# CY3271 Pig Tail Thermistor Connector Incorrect

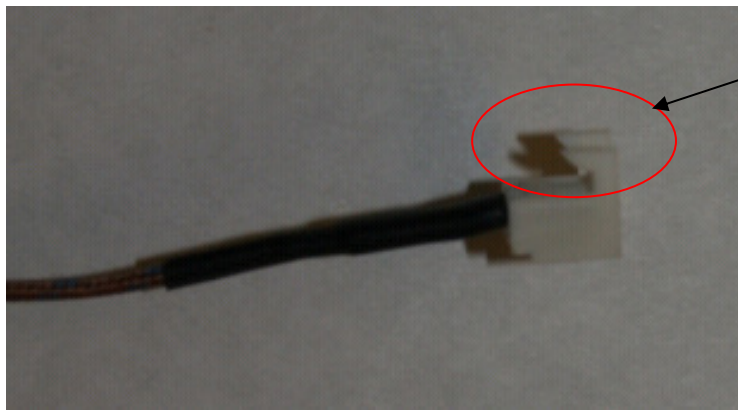
Question: The pig tail connector on the Thermistor does not fit the mating connector on the board.

Response: Remove prongs off thermistor connector with scissors. As polarization is not required for the thermistor, this will not affect the operation of the CY3271 RF Node board. Please refer the attached picture for reference.

Remove two prongs with scissors
